# ADDENDUM NO. 3

**Perry Meridian High School Phase 2 Renovations  
401 W. Meridian School Road  
Indianapolis, IN 46217**

This Addendum consists of Pages ADD 3-1, Lancer Associates Architecture Addendum No. 3, dated September 17, 2026, consisting of six (6) pages, and Addendum 3 Drawings: C-7.1, C-7.3, C-7.4, PF101, PP101, P-601, P-901, P-903, ED108, EP101, EP108, E-701, A202, A751, & A753

**ADDENDUM NO. THREE**

C-7.1

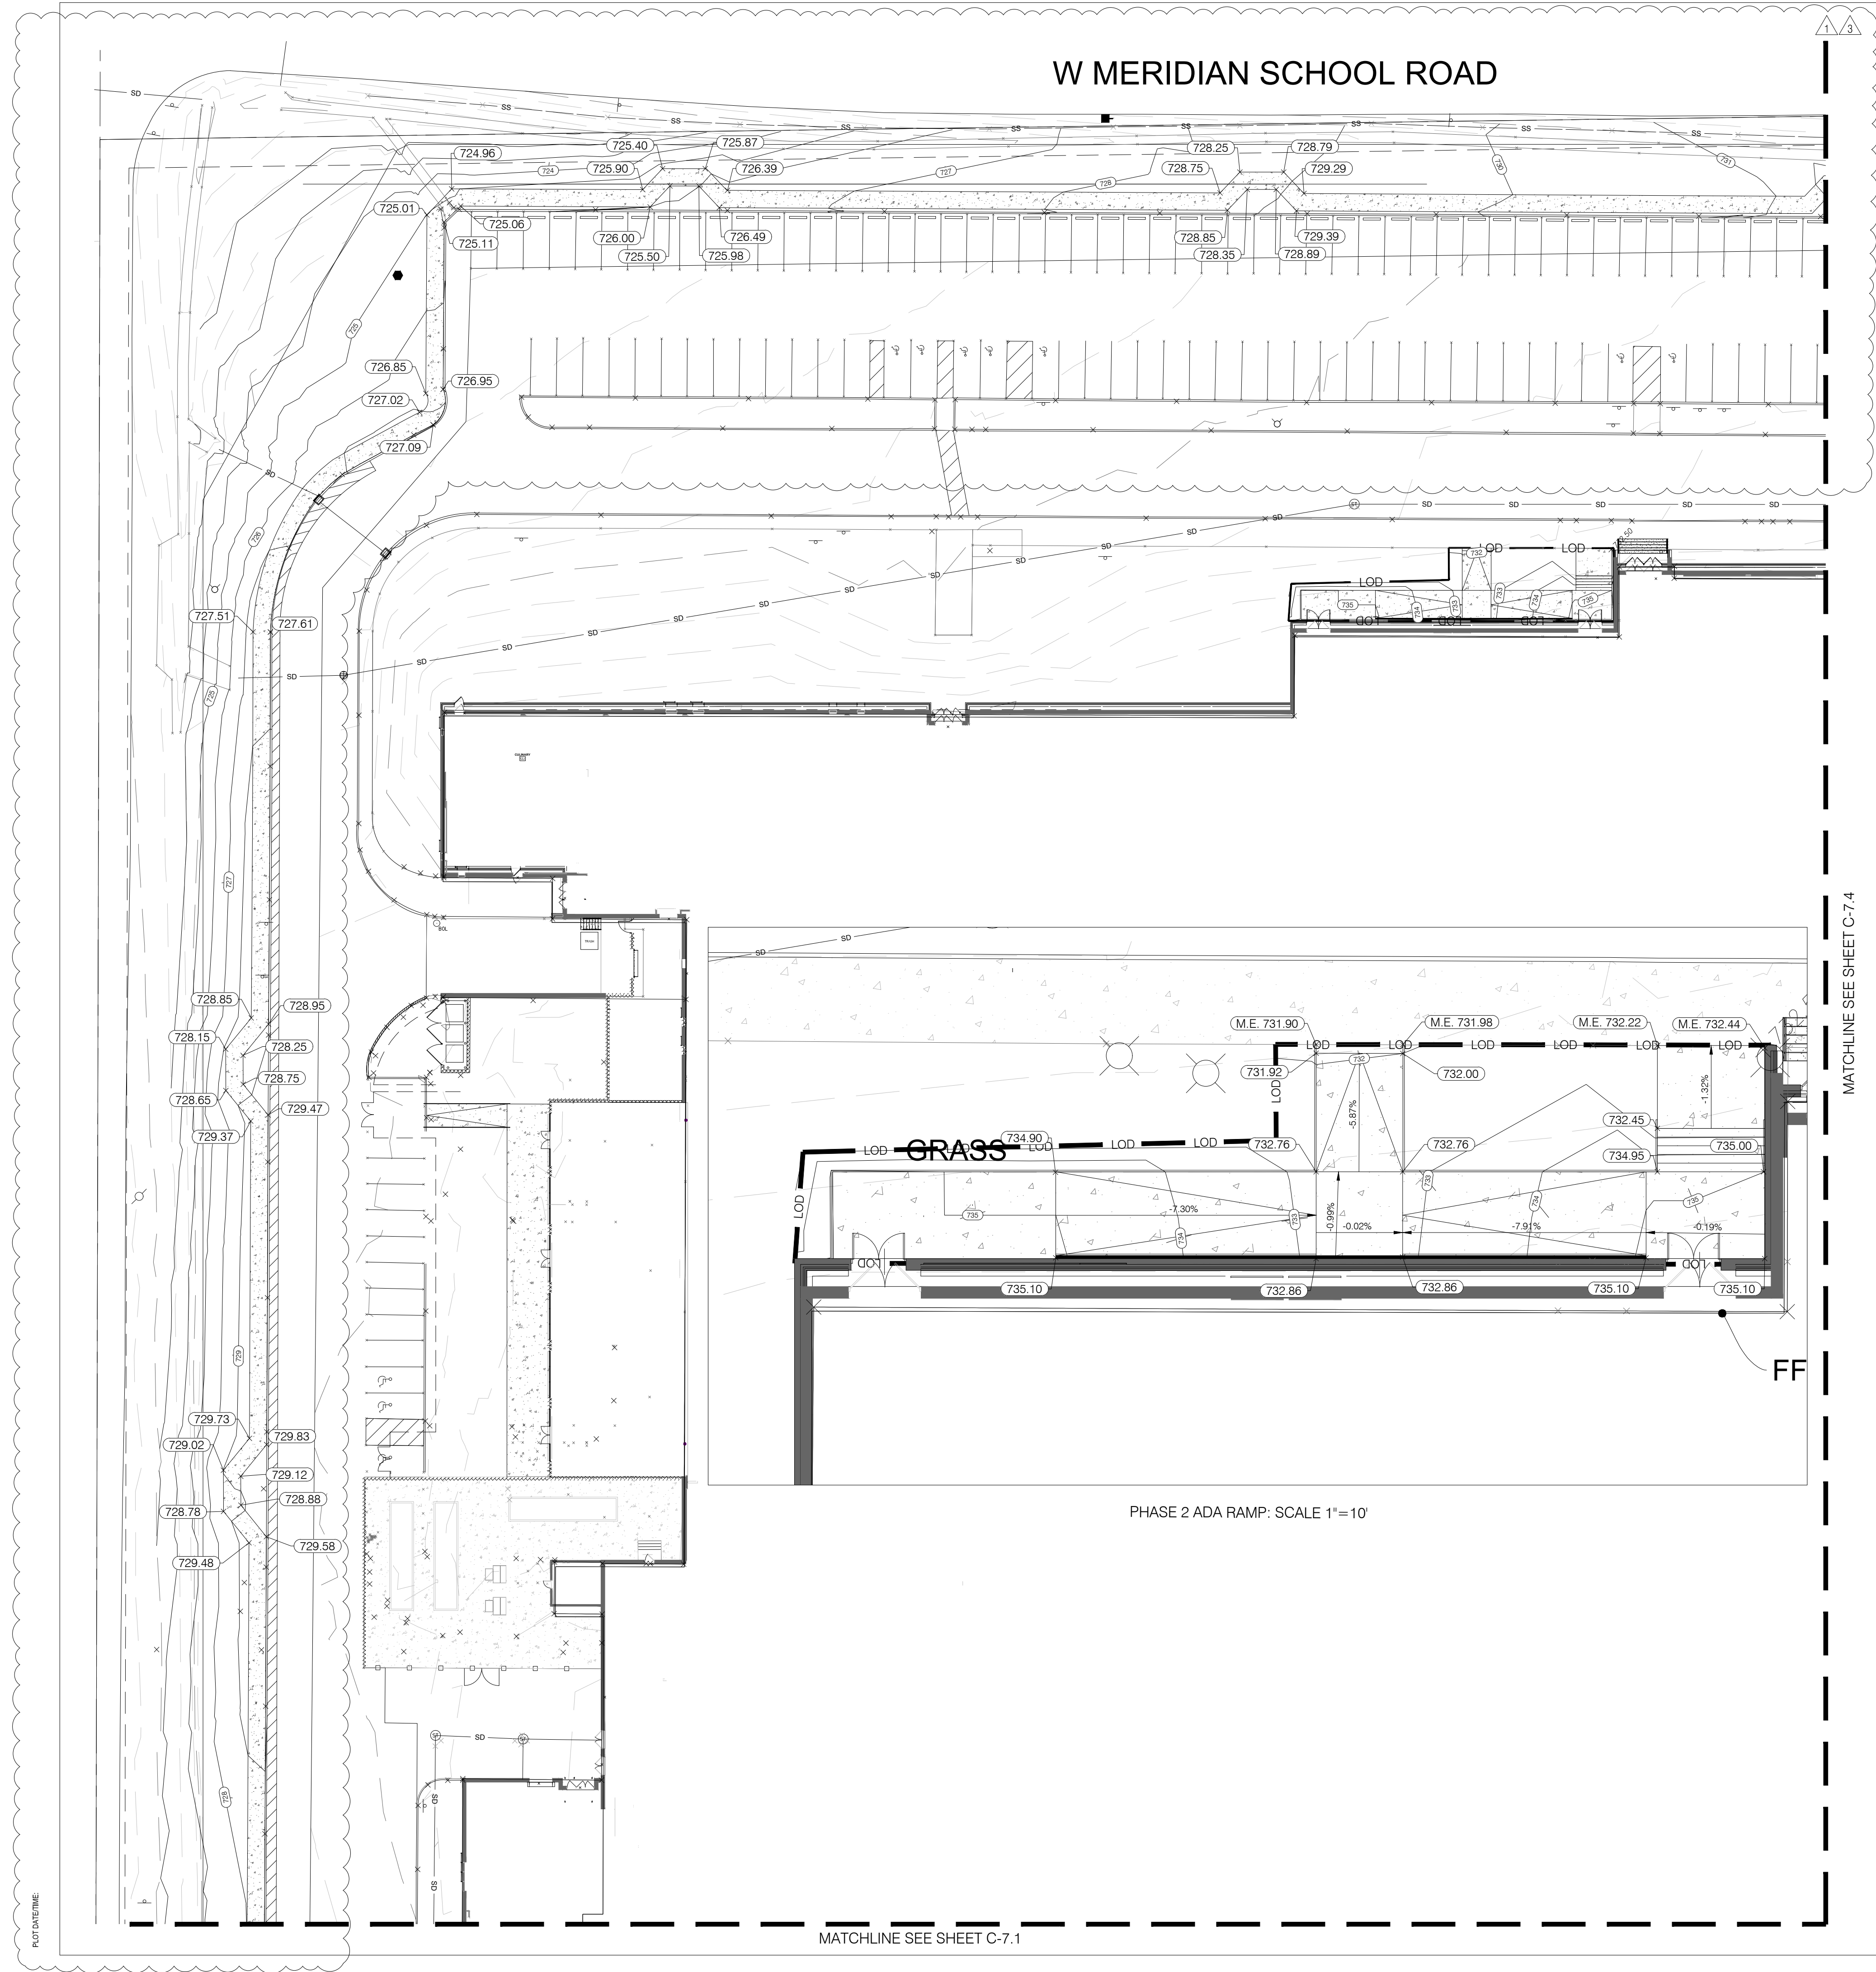
1. Sheet C-7.1

- Spot elevations for the proposed sidewalk have been updated.
- 2. Sheet C-7.3
  - Spot elevations for the proposed sidewalk have been updated.
- 3. Sheet C-7.4

C-7.4

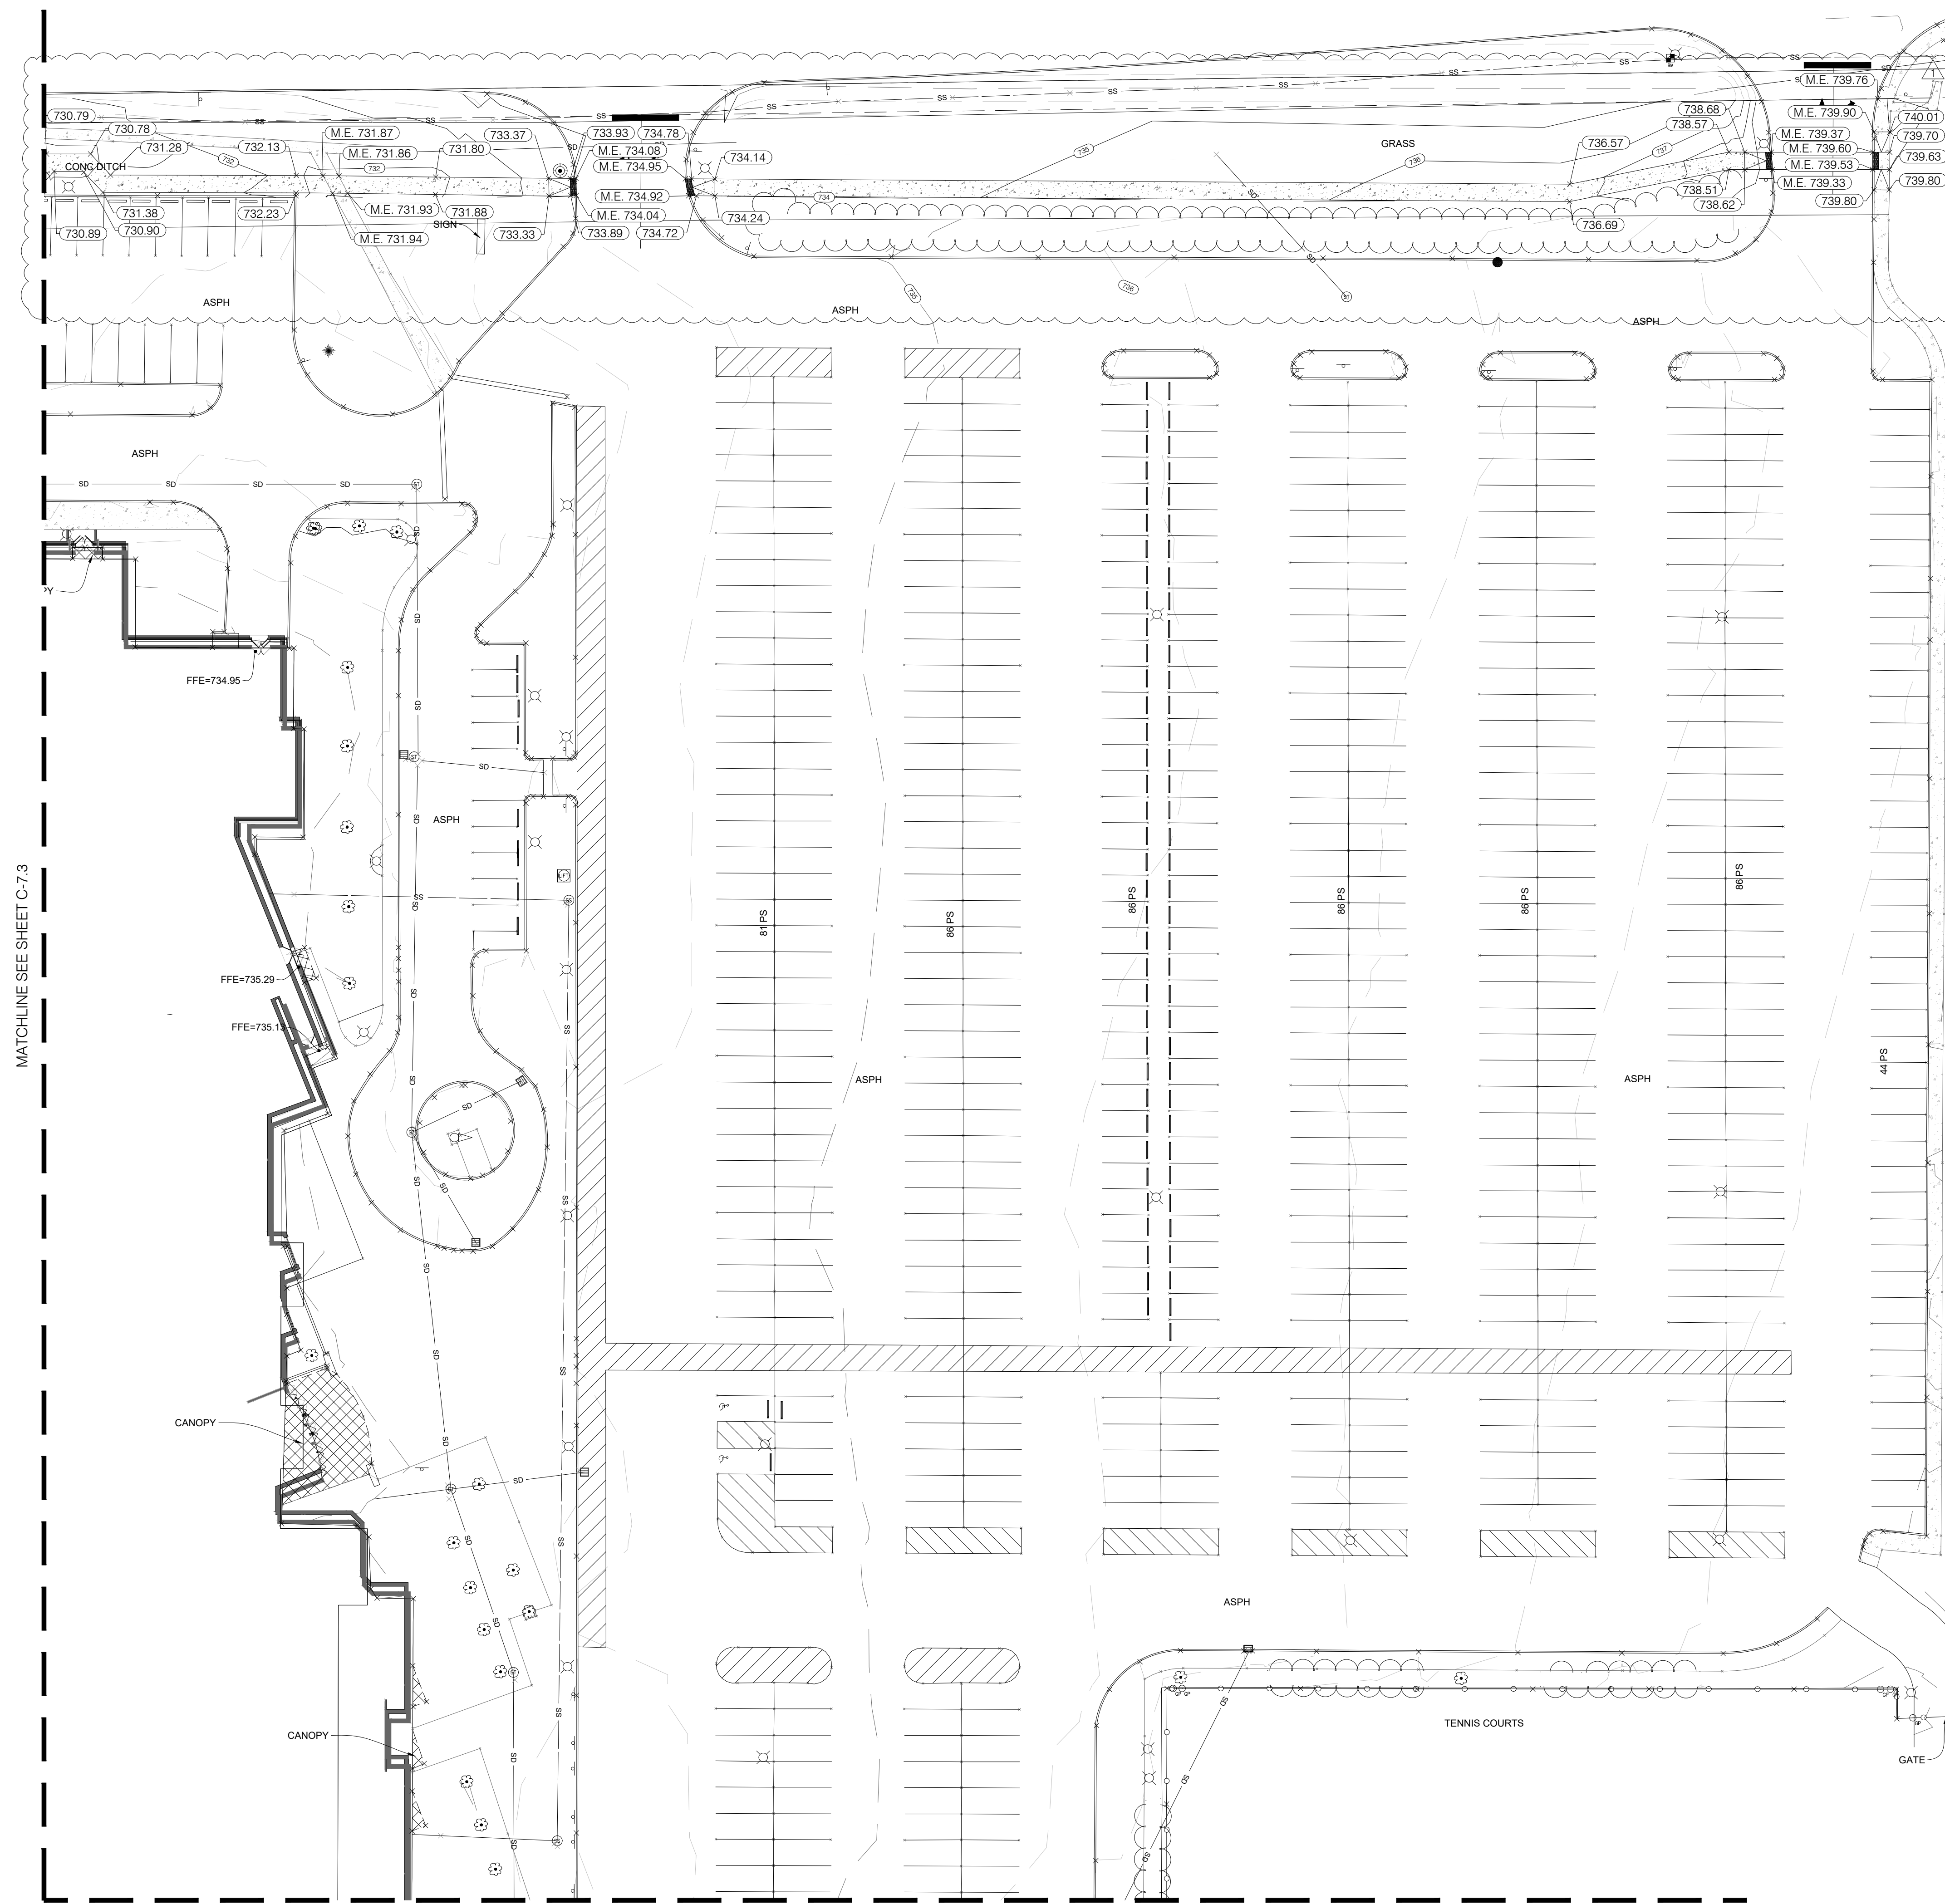
- Spot elevations for the proposed sidewalk have been updated
- 3. PF101 – plumbing foundation plan – unit A
  - a. Delete and replace in its entirety
- 4. PP101 – plumbing first floor plan – unit a

4 EXTERIOR ELEVATION - AUD. SOUTH WALL  
SCALE: 1/8" = 1'-0" REF. 1 / A102D

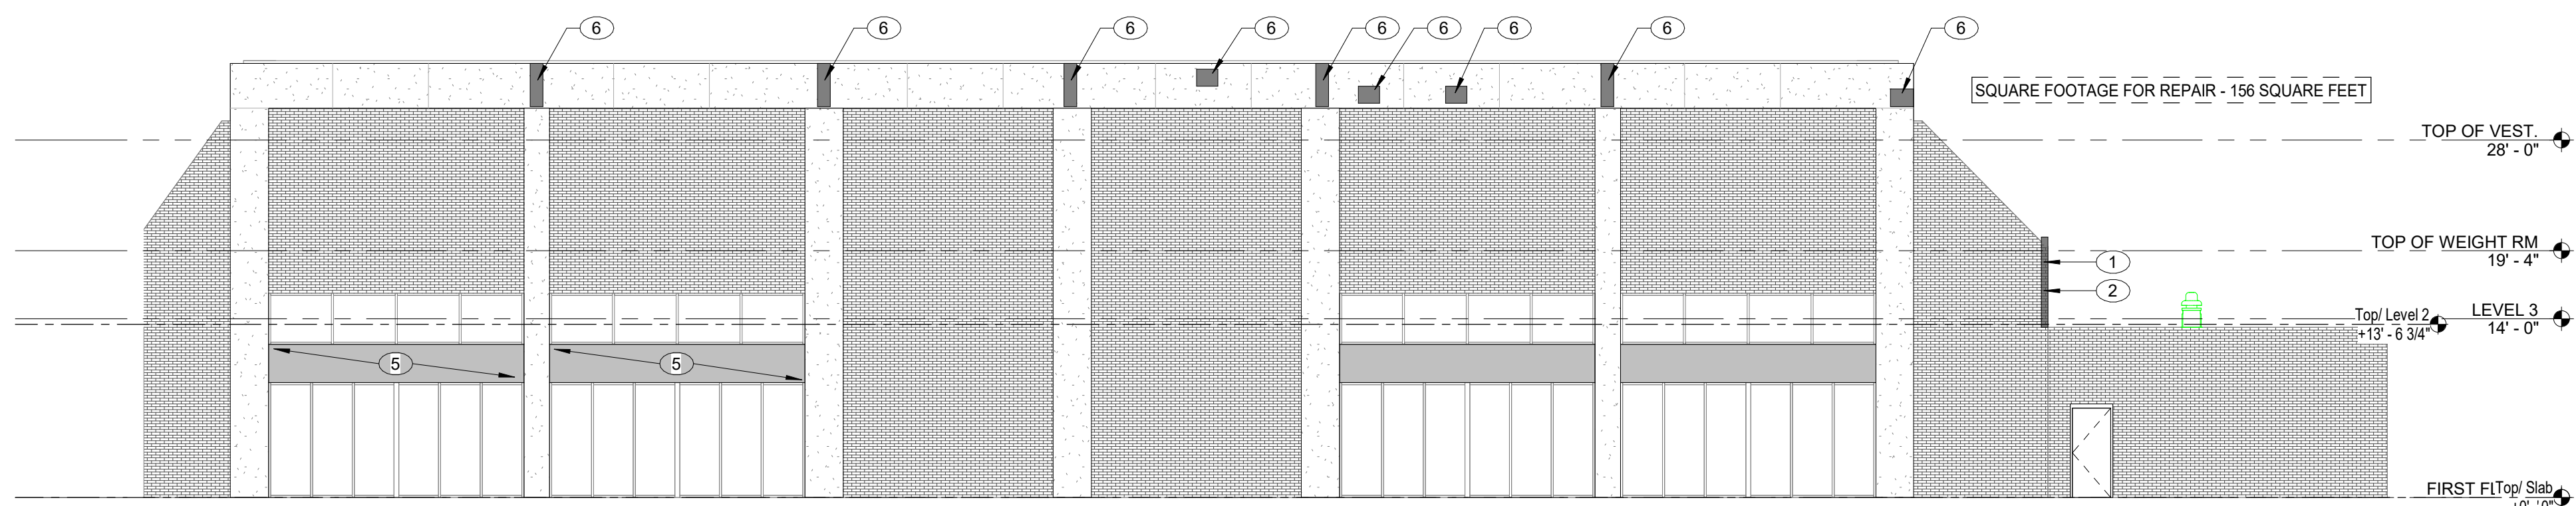
- a. Delete and replace in its entirety
- 11. E-701 – electrical one-line diagrams
  - a. Delete and replace in its entirety
- 12. Sheet A202
  - a. On Detail 4/A202 the amount of brick to be replaced has been reduced

5 INT. ELEV. - ENSEMBLE 12A W  
SCALE: 3/8" = 1'-0" REF. 1 / A721D

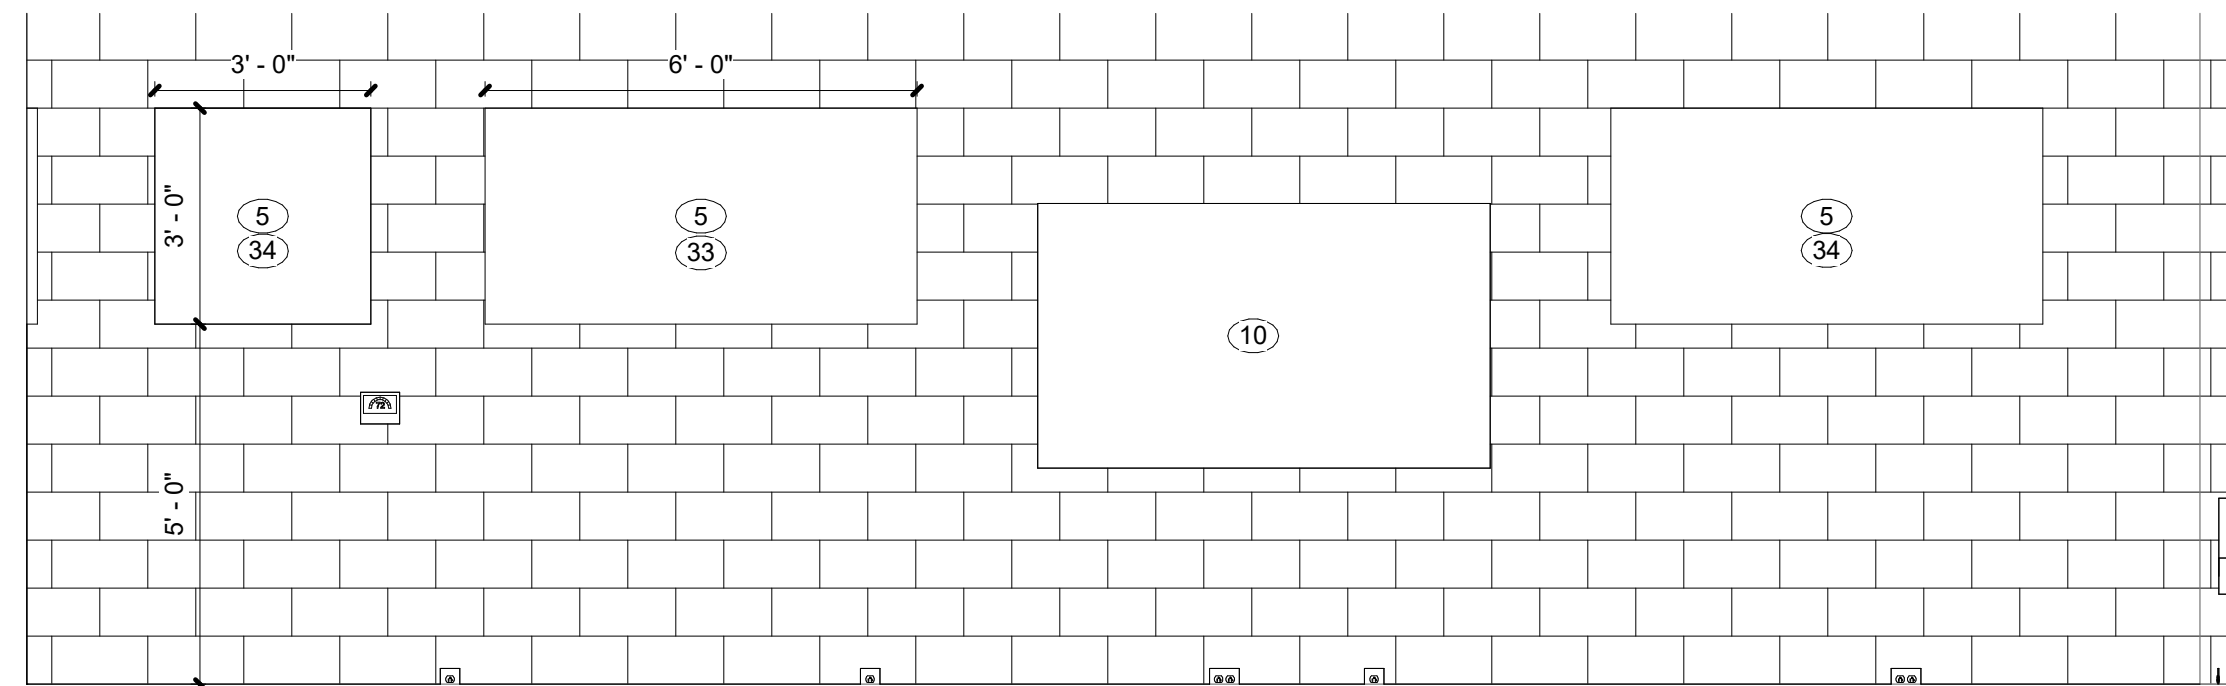
- 13. Sheet A751
  - a. Added acoustical wall panel fabric finish to 1/A751, 2/A751, 4/A751, and 5/A751.
- 14. Sheet A753
  - a. Added acoustical wall panel fabric finish to 2/A753, 3/A753, 5/A753, and 6/A753
